MEMORANDUM FOR: Edward F. Hawkins, URFO
FROM: Myron H. Fliegel, Section Leader
WMGT
SUBJECT: REVIEW OF MONUMENT VALLEY DRAFT REMEDIAL ACTION PLAN

Monument Valley DRAP
Surface Water Hydrology
Questions and Comments

SUBJECT: THE GROUND-WATER SECTION OF THE MEXICAN HAT TECHNICAL
EVALUATION REPORT (TER)

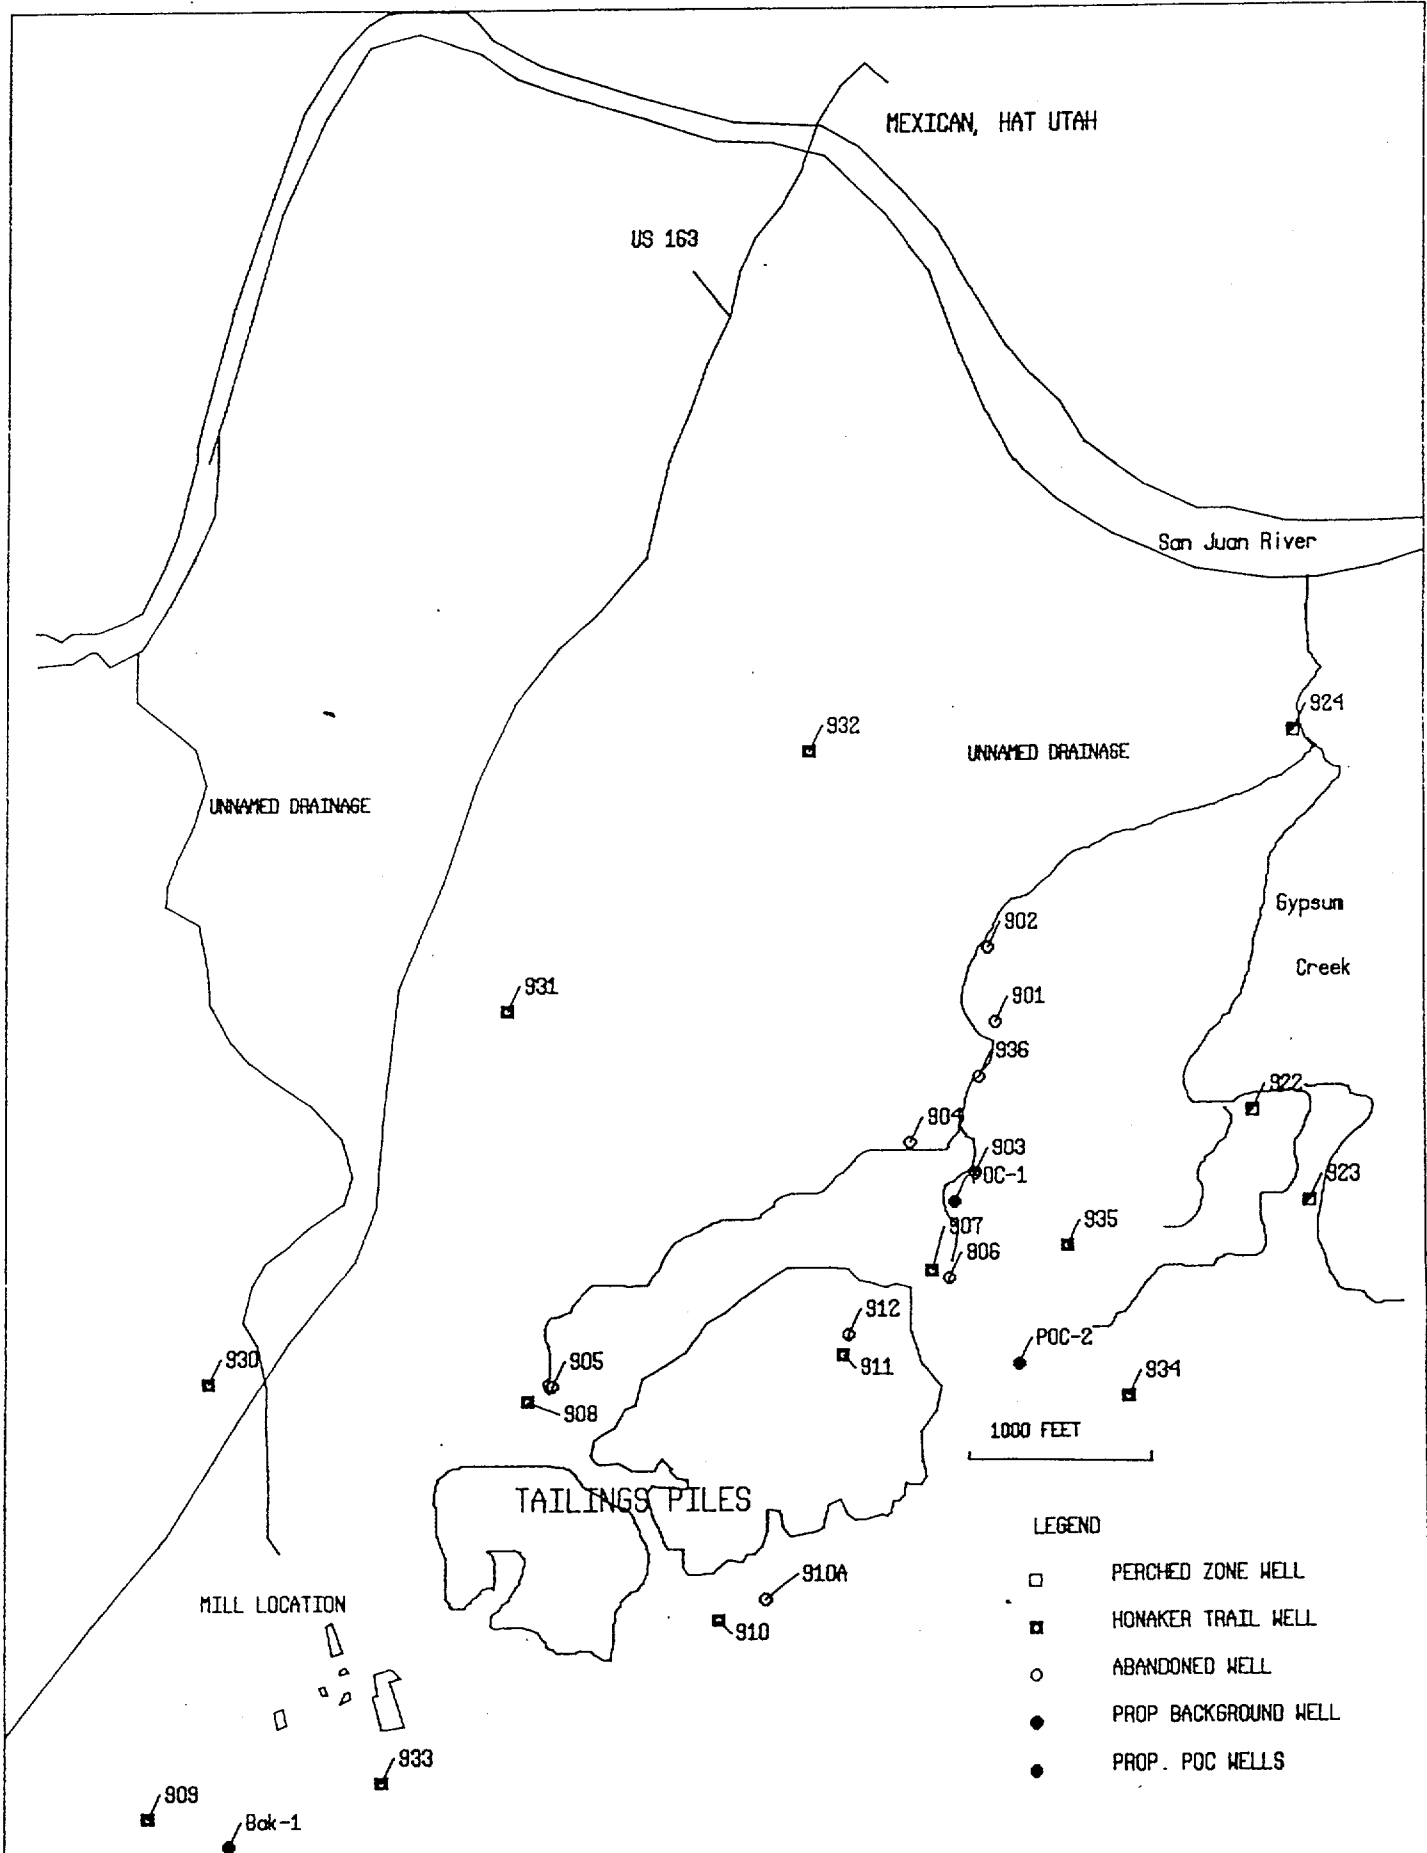
In a letter dated April 11, 1989, NRC requested DOE to propose background and point of compliance well locations for the Honaker Trail Formation (middle hydrostratigraphic unit) the uppermost aquifer. DOE responded June 8, 1989, by proposing installation of two point of compliance wells downgradient of the disposal cell and one upgradient background well. DOE stated that the background well may be an existing well (such as 909) or a new well. The locations of these proposed wells are also shown in Figure 1.2.1.

Figure D.7.9
FIGURE D.7.9
TRILINEAR DIAGRAM, MEXICAN HAT SITE

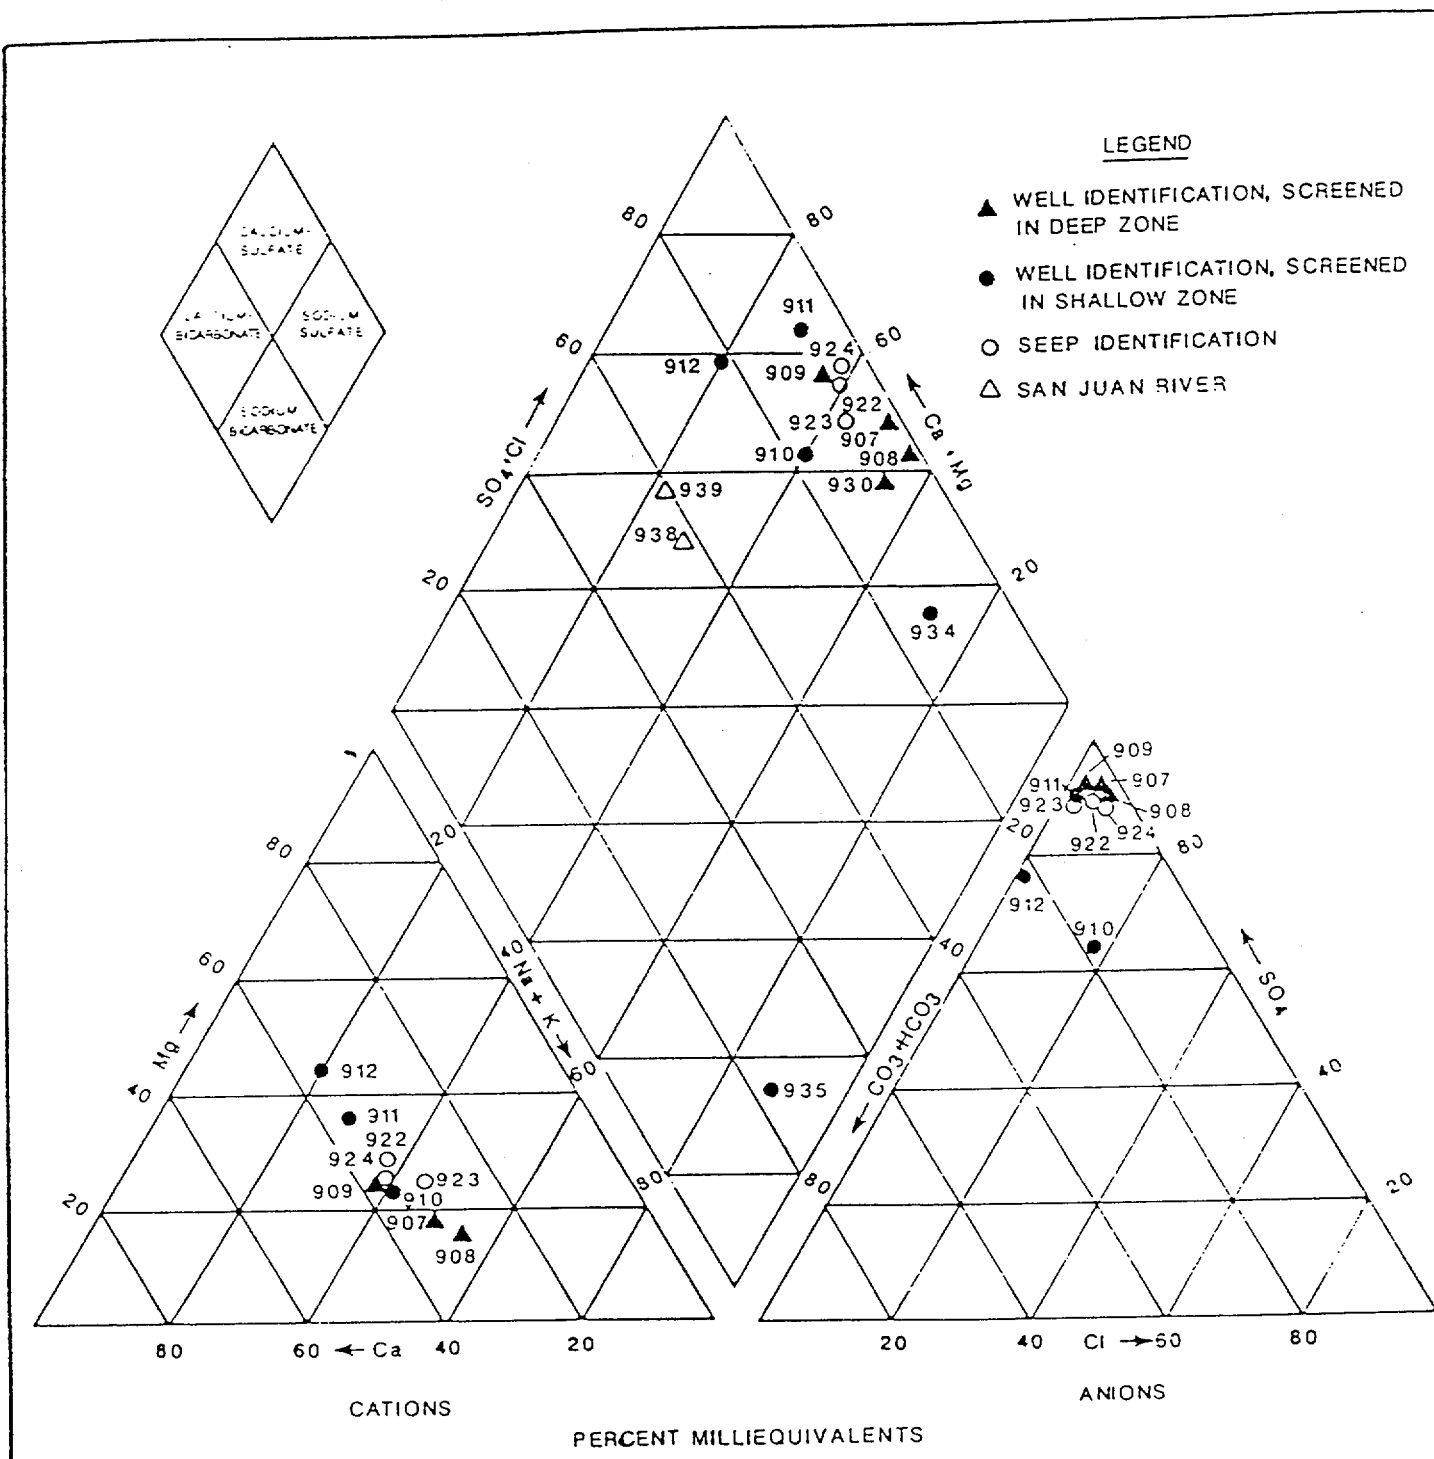
Water quality of the upper and middle hydrostratigraphic units is classified as brackish, moderately hard to hard, and is a calcium-sulfate type ground water. Figure 1.2.1 is a trilinear diagram of ground water from the site (from Figure D.7.9, page 202, of Appednix D of the DOE Jyly 1988 Final R.A.P.). Table 1.2.1 summarizes the water quality of the middle hydrostratigraphic unit (from Table D.7.8, page 2-13 of the DOE July 1988 Final R.A.P.).
